Document ID: IK1600064
Revision: 2
Created: 10/16/2007
Last Modified: 3/12/2014
Author: Patrick Gotschall

Title: ProStar No Idle Curtains Missing Velcro

Applies To: ProStar

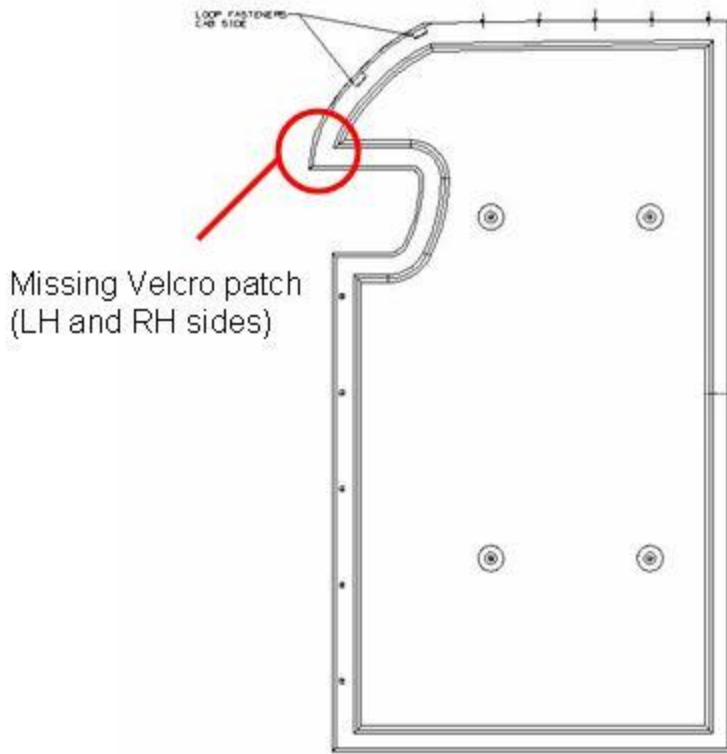
No idle curtains missing Velcro Patch (driver and passenger).

- Missing patch will have minimal effect on the performance but patch can be sewed on if need.
- Production fix is estimated to be ready by December 1 with suffix revisions 3805702C2 (LH dark neutral) & 3805707C2 (RH- Blue).
